REMARKS

This is a full and timely response to the outstanding non-final Office Action mailed on March 21, 2002. Allowance of the application and presently pending claims, as amended, are respectfully requested. Upon entry of the amendments in this response, claims 12-17 are cancelled without prejudice, waiver or disclaimer, and claims 20-23 are added. These additions are specifically described above. It is believed that the additions add no new matter to the present application.

Drawings Objections

FIG. 1

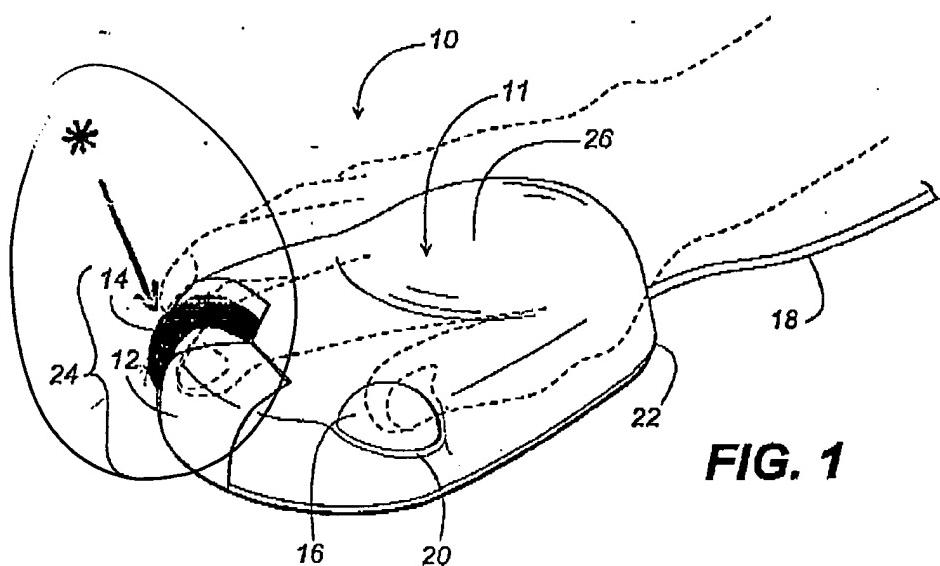
The drawings have been objected to under 37 CFR 1.83(a) for not showing the claimed element "scroll wheel" in claim 16. In response to this objection, Figure 1 of the drawings has been amended to show a "scroll wheel" to Figure 1. This Response contains a second amendment to the drawings (to Figure 2) for newly added claims 20-23. The amendment adds no new matter to the present application.

Support for the claimed element "scroll wheel" is found in the specification. (p. 17, lines 21-22 and Figure 1, as amended by this response).
